Milldale Fast-Track

29/07/2025 – Auckland Council Response

Technical Specialist Memo – Senior Stormwater Specialist, SWWWITA

Fast-Track project name: Milldale

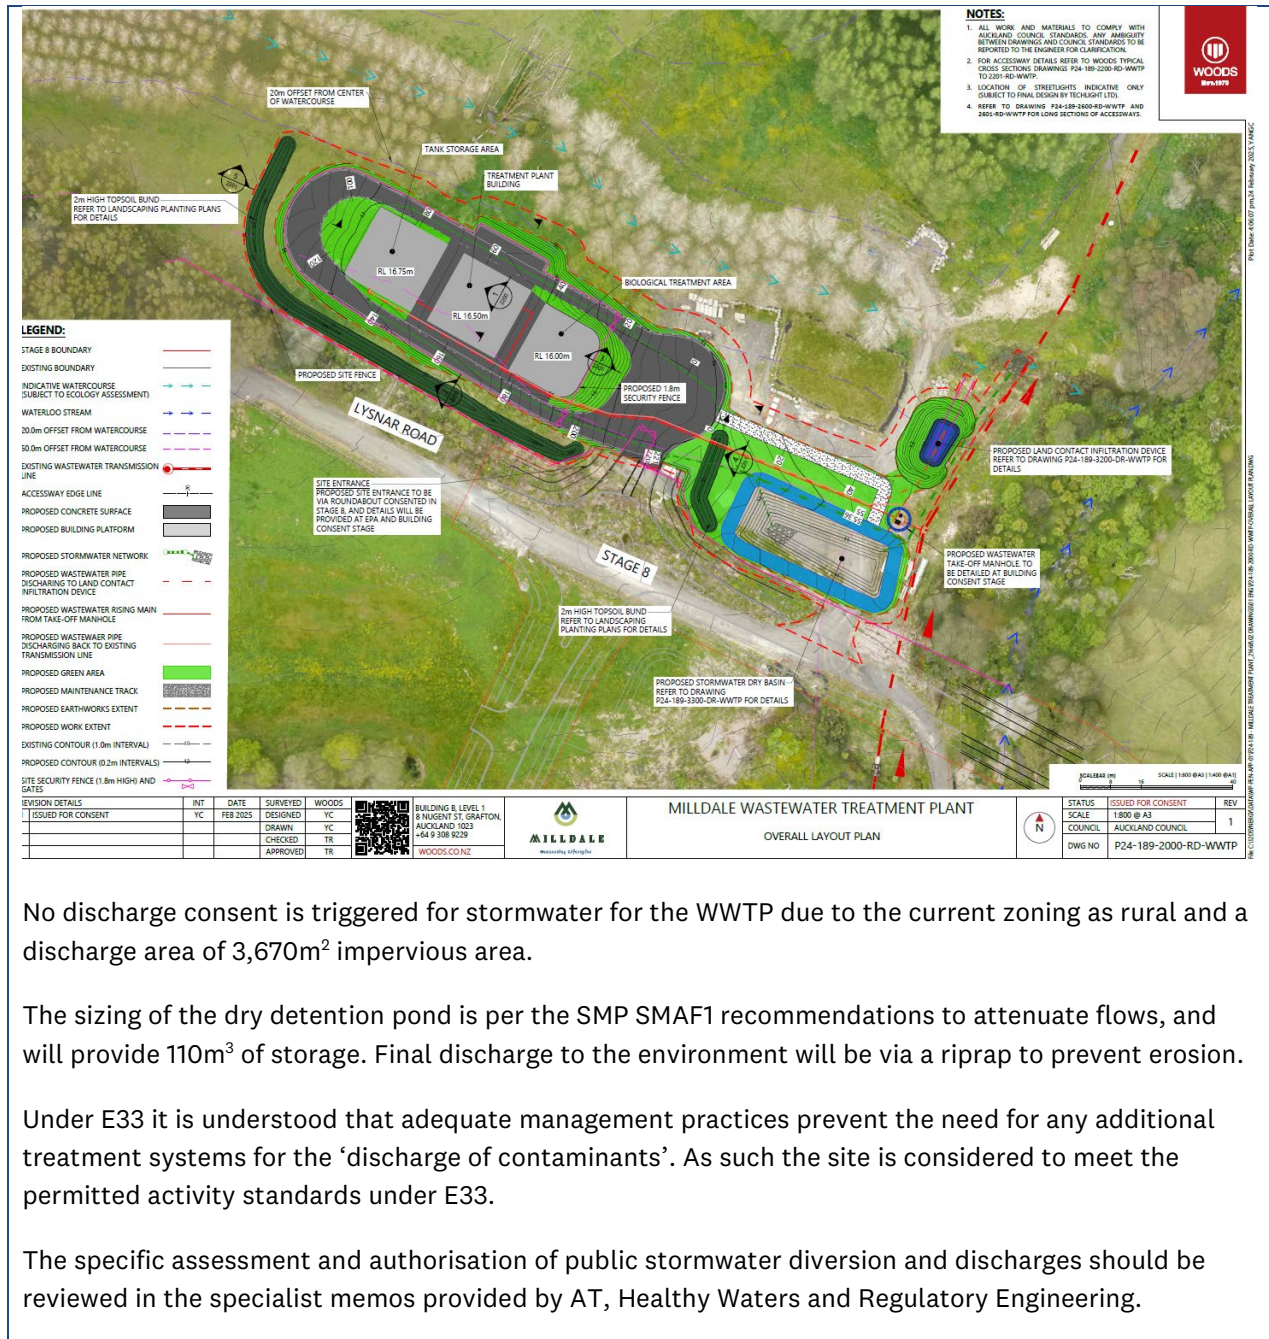
Impervious areas within the development are proposed to discharge via public outfalls to the public network (authorised by Healthy Waters under the regionwide NDC). At this stage it is unclear that the proposal will be accepted under the NDC.

Where impervious areas are proposed to discharge privately within the development can be authorised under E8. The waste water treatment plant is confirmed to require a private authorisation.
